RE: CERTIFICATION FOR ST. JOSEPH'S HOSPITAL COMPLEX
SLOPE EROSION CONTROL PORTION
(K-15/D6) ENGINEER'S STAMP DATED MARCH 8, 1989

PROJECT TITLE: St. Joseph's Hospital Complex ZONE ATLAS/DRNG. FILE #: J-K-15-Z

**DRAINAGE REPORT AND PRELIMINARY GRADING PLAN
FOR
ST. JOSEPH HOSPITAL COMPLEX**

ST. JOSEPH'S HOSPITAL DOWNTOWN LOCATION	
Project No. _____	
PARKING LOT EXPANSION	
GRADING PLAN	
Job No. 20255-03	Sheet 2 of 2
Drawn By: JRT	Date: 6/18/91
Checked By: JRT	Scale: 1" = 50'

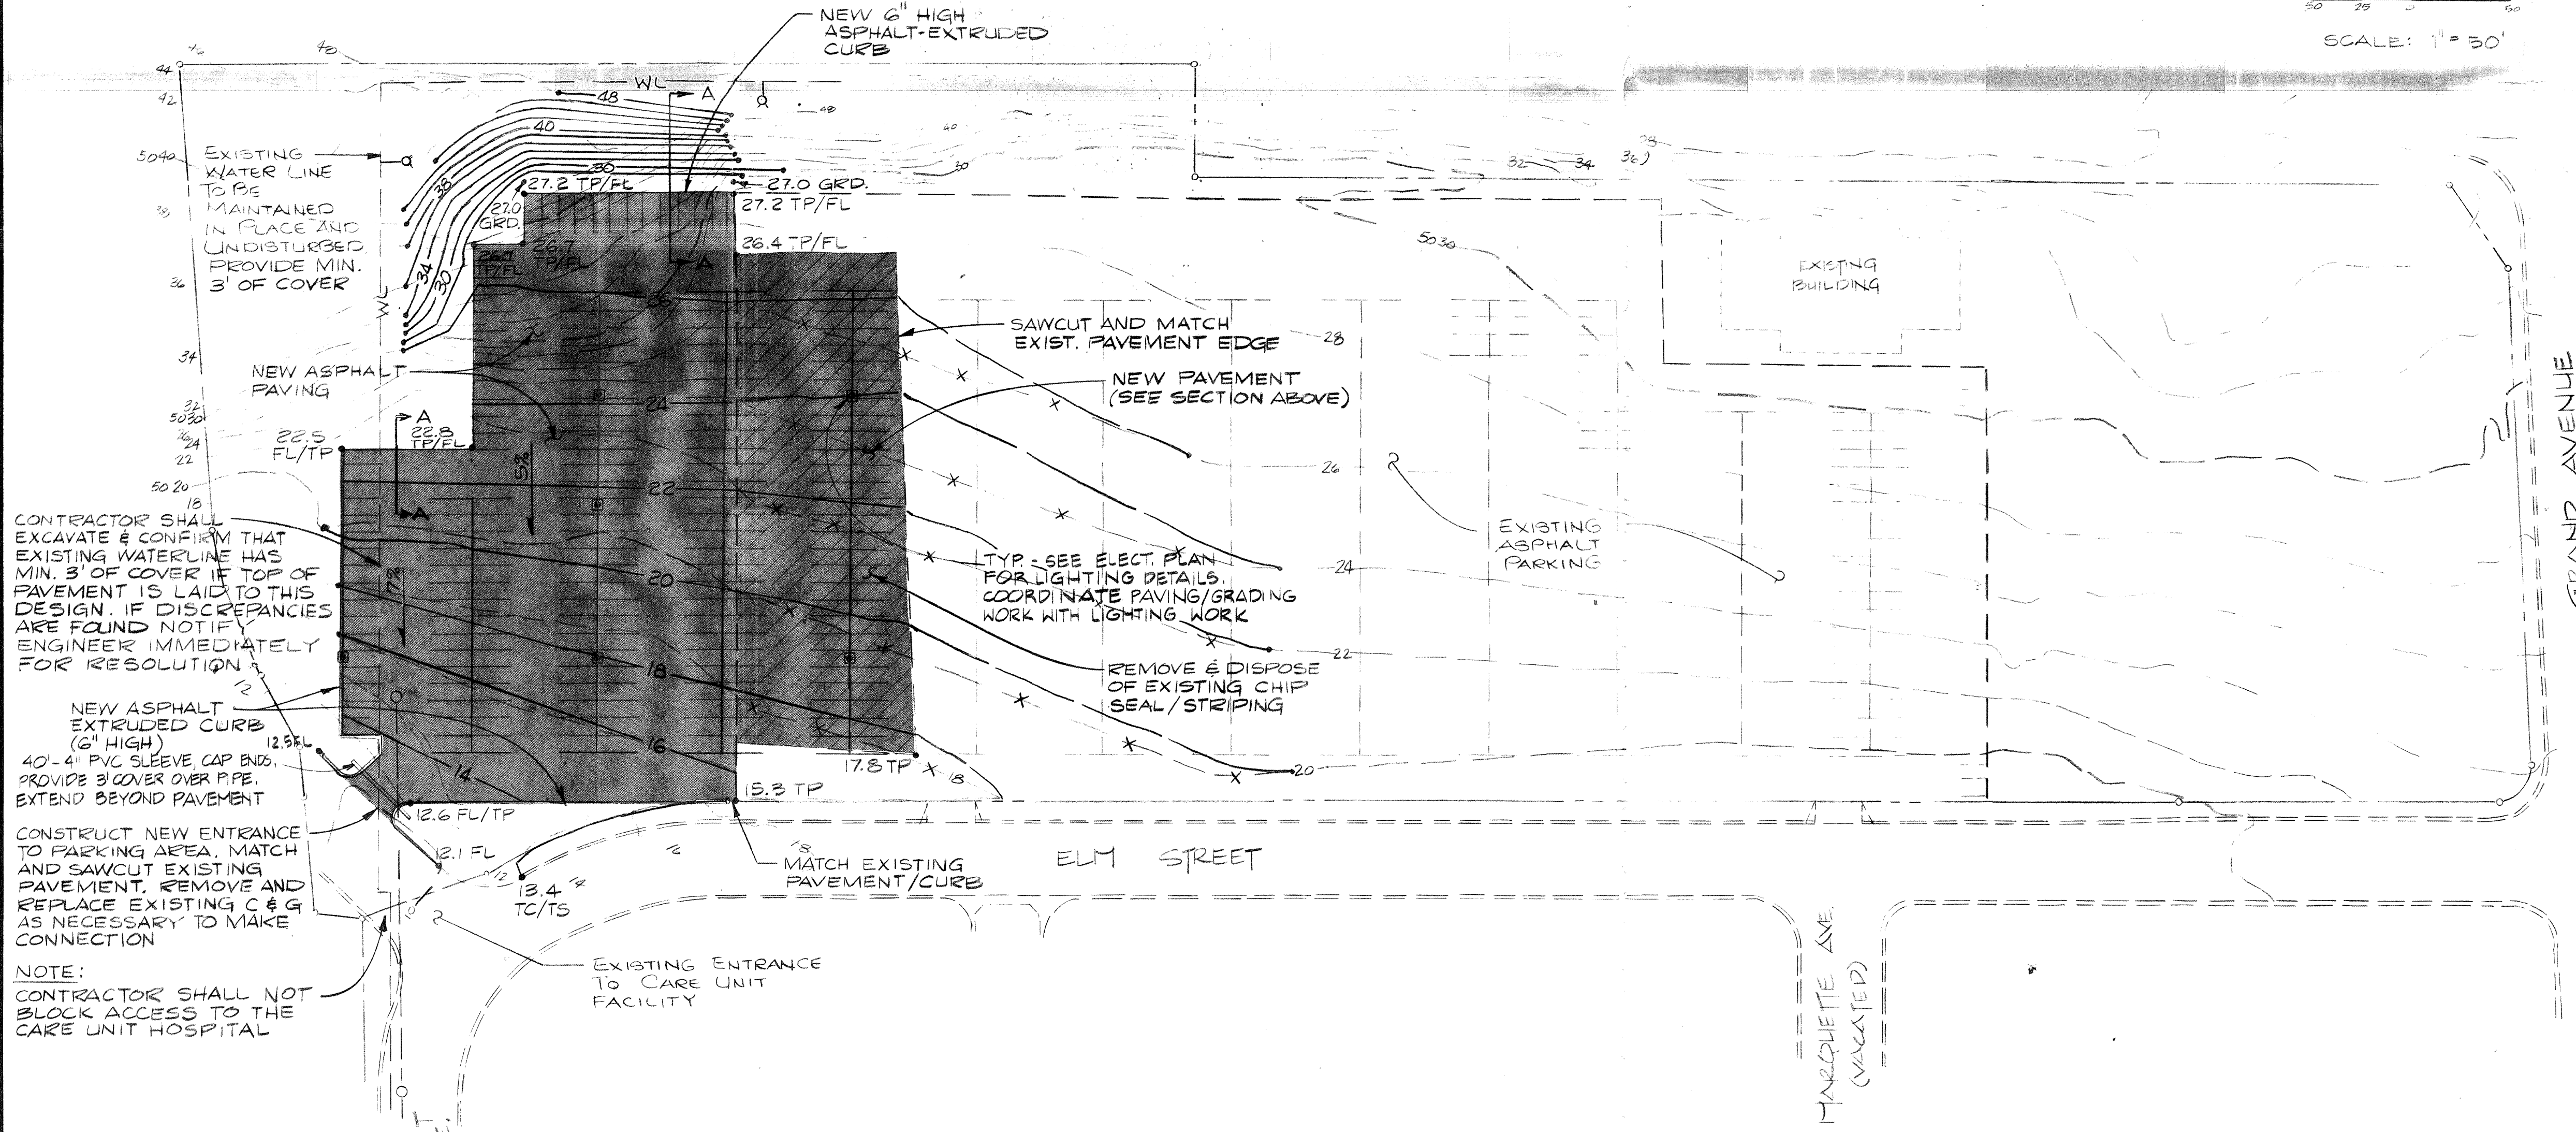
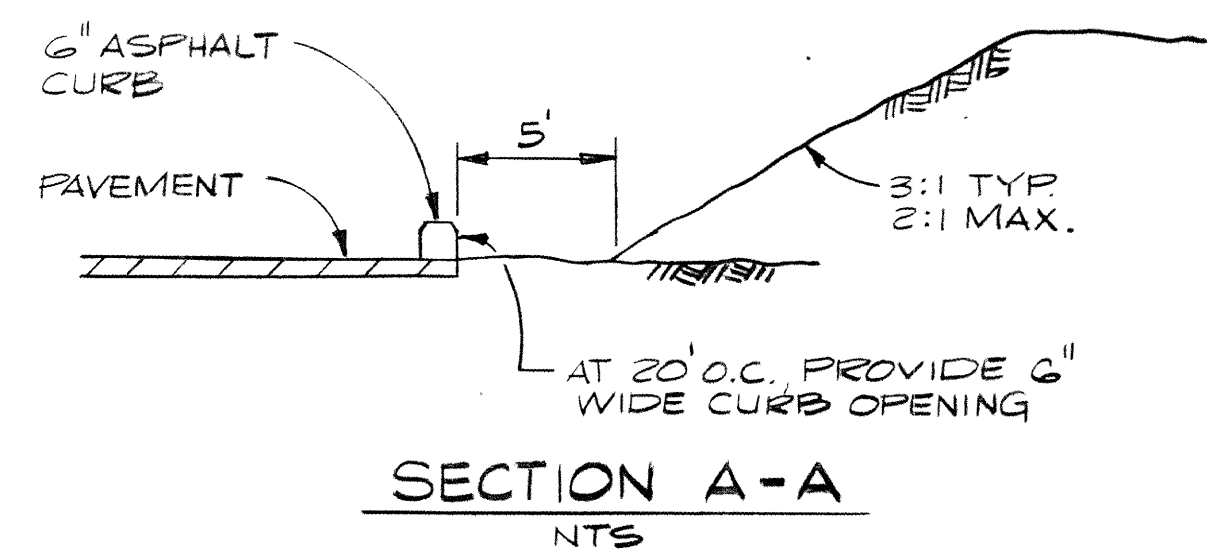
1. Please indicate an asphalt extruded curb all along the west perimeter of the parking lot.
2. Include your drainage calculations on the plan drawing.

Based on the information provided on your July 23 1991 submittal, the above referenced site is approved for grading/paving.

DRAINAGE PLAN
ASBUILT
FOR
TRACT 1
ST. JOSEPH HOSPITAL COMPLEX
ALBUQUERQUE, NEW MEXICO
OCTOBER, 1988

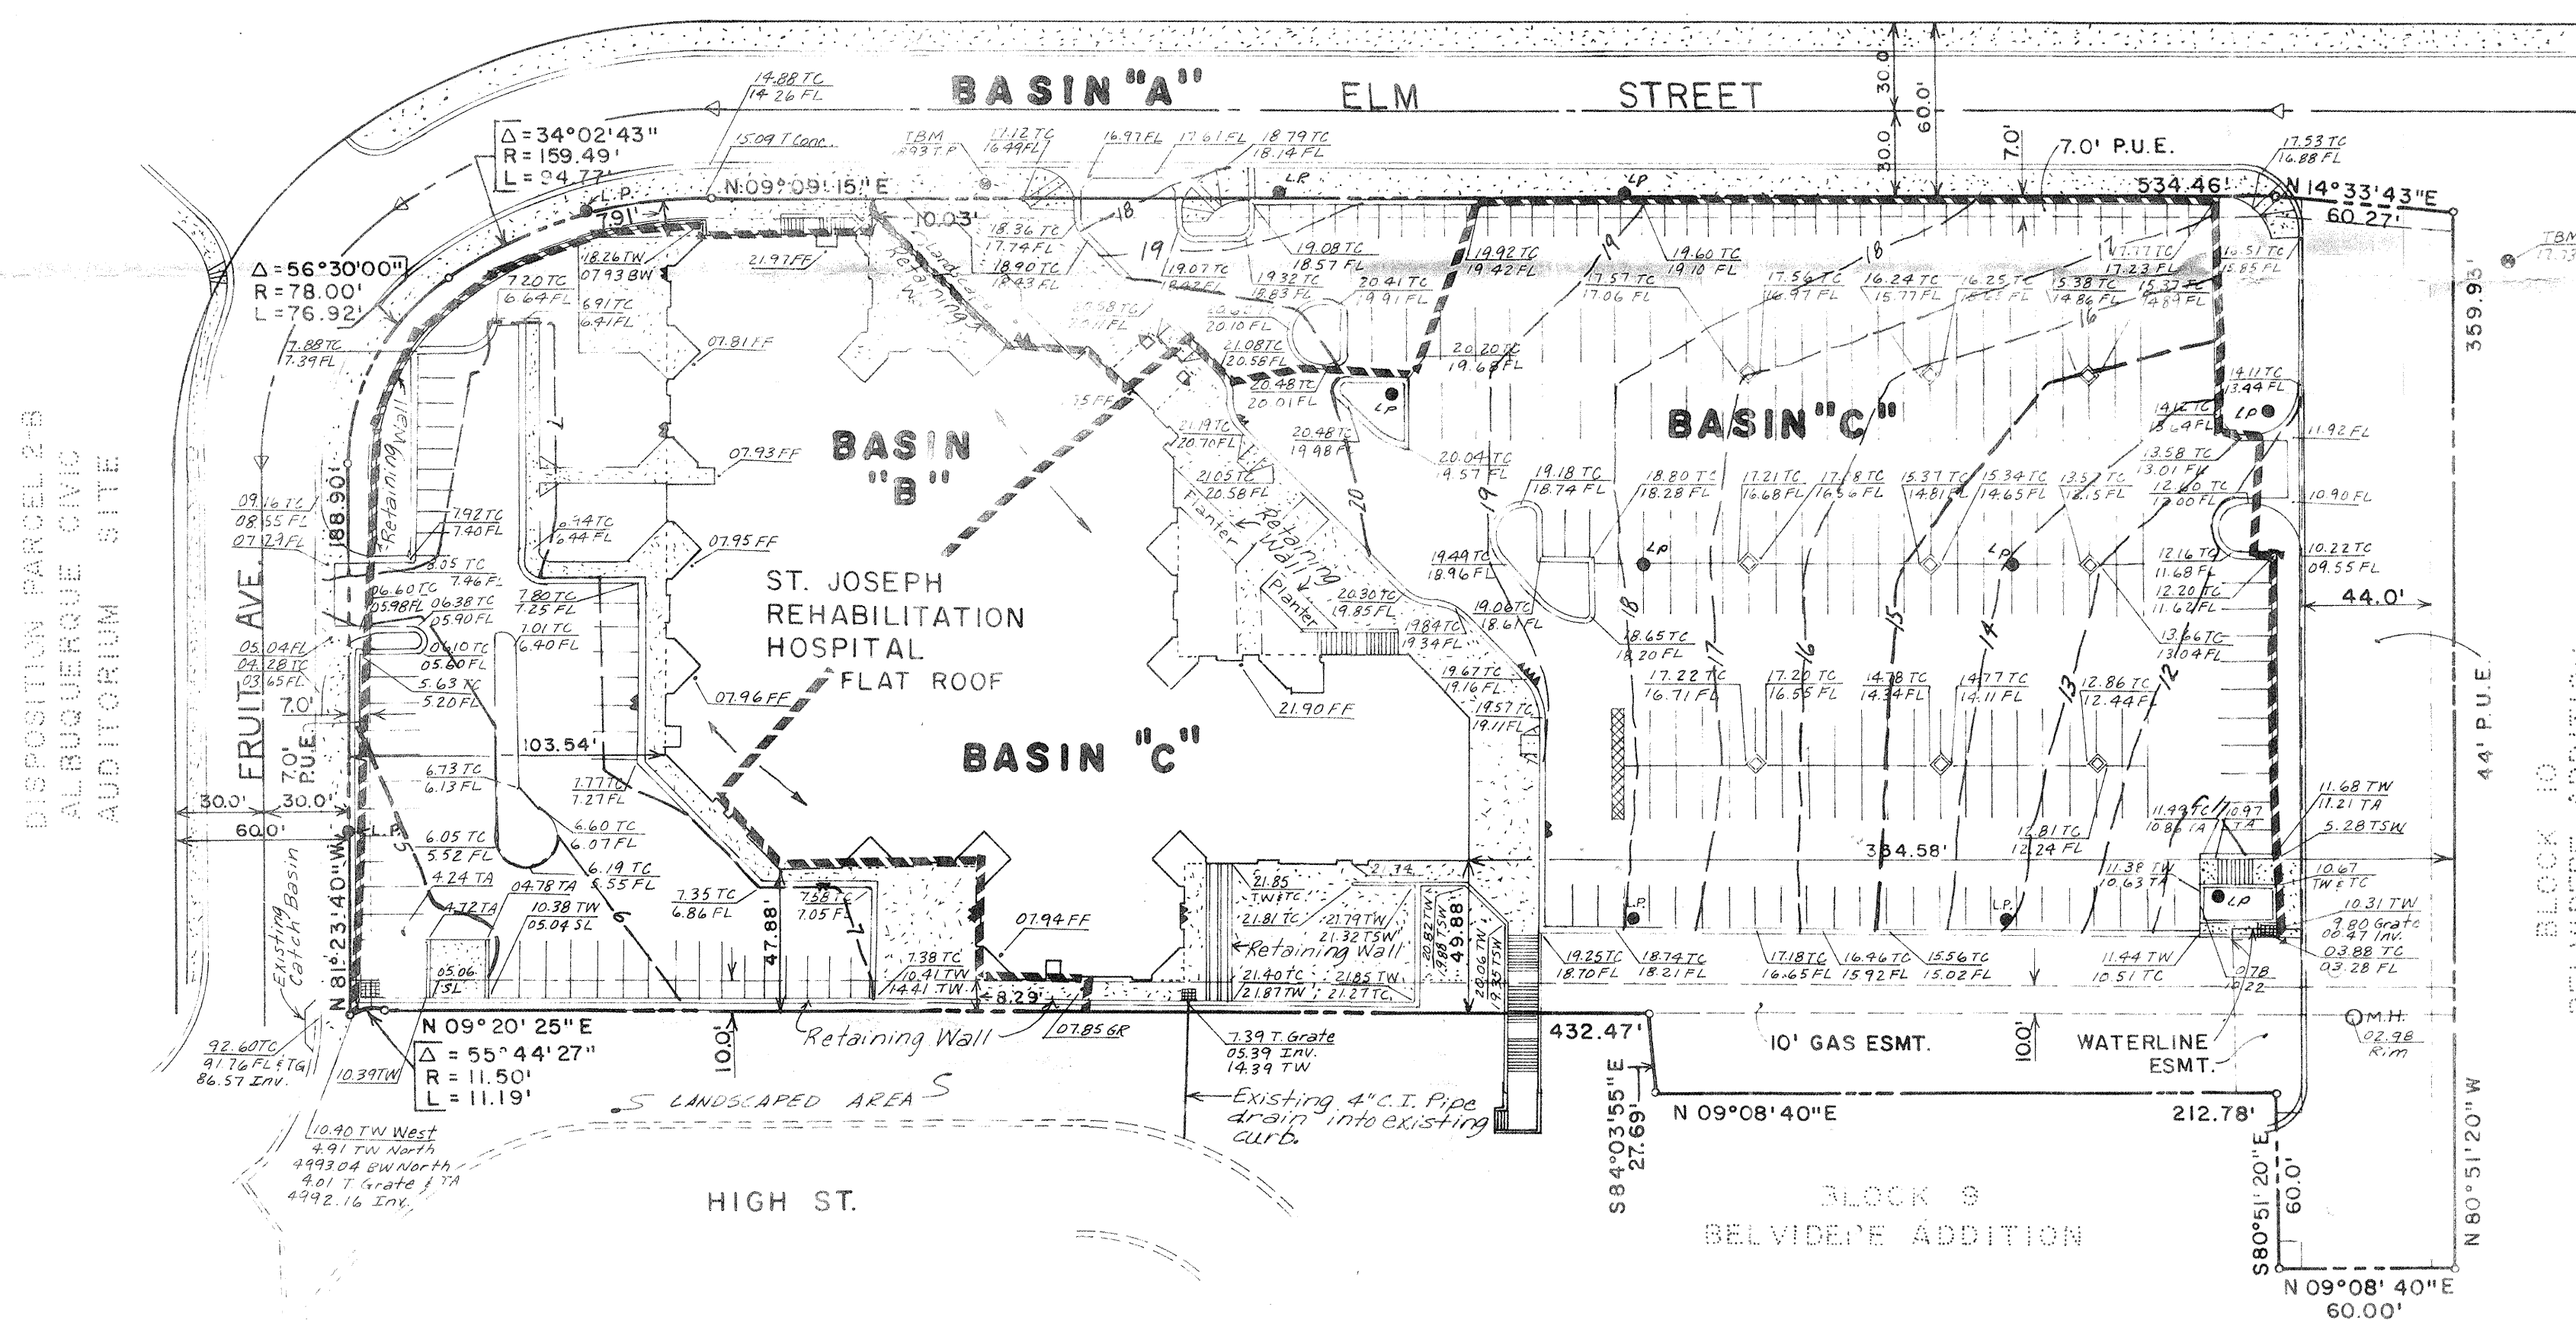
- ✓ 1. Copy of letter of acceptance for Work Order No. 3156.
- ✓ 2. Concurrence from the City Inspection Department for the work done under S.O. #19 process.
3. You must indicate on your plan all as-built structures that correspond to the site project. You indicate a 2' x 2' grated catch basin on the west side, but you do not indicate the 4" C.I. pipe. Please address.
4. Note indicating that Certification is only for the portion shown on the Certification plan and no other areas shown on the original approved drainage plan done by Bohannon-Huston, Inc.

Please be advised that besides the above listed concerns, the problem of erosion on the west slope of the new Rehabilitation Hospital must be corrected and certified prior to issuing a permanent Certificate of Occupancy. Once the above four concerns are satisfied, a Temporary Certificate of Occupancy will be issued until Certification is received for work done for the erosion control.

Based on the information provided on your resubmittal of March 9, 1989, the revised Certification is acceptable. Please be advised that the problem of the erosion on the west slope of the new rehabilitation hospital must be corrected and certified prior to issuing the permanent Certificate of Occupancy.
